Publisher Correction: Spin-transfer torque magnetoresistive random access memory technology status and future directions

Correction to: Nature Reviews Electrical Engineering https://doi.org/10.1038/s44287-024-00111-z, published online 6 November 2024.

https://doi.org/10.1038/s44287-024-00123-9

Fig. 1 | Original and corrected Box 2 figure.

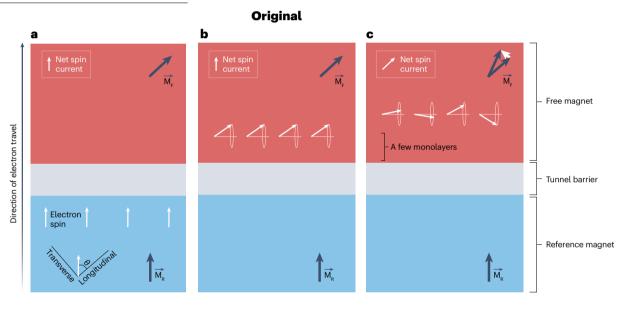
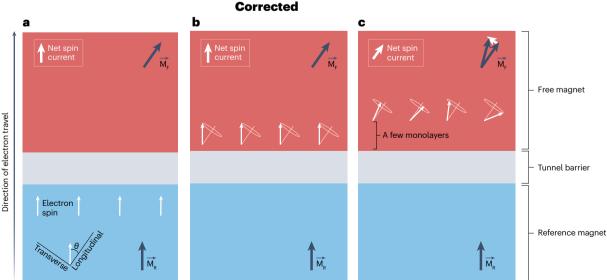
In the version of the article initially published, in panel b and c of the Box 2 figure, when the spins precess in the "free magnet" section, the spin direction was mistakenly drawn and has now been corrected in the HTML and PDF versions of the article. The original and corrected figure can be seen in Fig. 1.
